From: Barela, Maximo <Maximo.Barela@nnsa.doe.gov>
Sent: Tuesday, December 06, 2016 6:18 PM
To: Garcia Santos, Norma
Cc: McKirgan, John; Tarantino, David; Mccollum, David E; Chavez, David Michael; Mumma, James; Taplin, Temeka; m_mb7073@msn.com
Subject: [External_Sender] RE: 435-B, Rev. 1 - Clarification Needed
Attachments: Lid Weldment.JPG
Importance: High

NRC statement: “This clarification is related to the weld symbol for Item 5 shown in Section B-8 included in drawing No. DWG 1916-01-03-SAR, Sheet 2.”

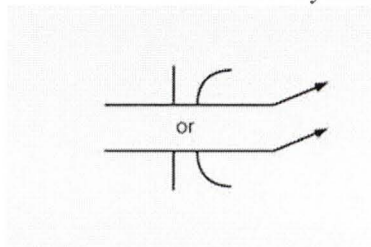
NRC Statement: “By looking at the drawing, the drawing the symbol shows a plate/stiffener welded to a tube, item 5 which shows 1/4" fillet welds both sides, which the staff thinks that it technically should be flare bevel both sides. See below symbol for welding tube to plate.

The staff wants to understand why the applicant uses a fillet weld in lieu of flare bevel.”

NNSA Response: The NRC also mentions a plate/stiffener welded to a Tube. Section B-B does not include a tube as indicated in NRC’s statement quoted above. Item 5 is a rectangular block. See the attached isometric

view. The NRC text mentions a ¼ inch fillet weld on both sides. However, the entire length of both sides of each rectangular block are welded using 3/16" fillet welds. Therefore, there is no place for a flare-bevel weld in the lid.

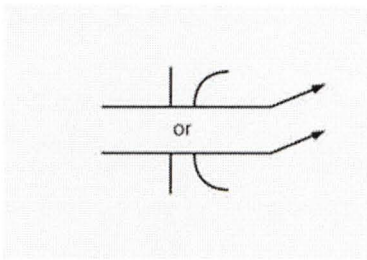
The staff wants to understand why the applicant uses a fillet weld in lieu of flare bevel or flare bevel with reinforcing fillet.
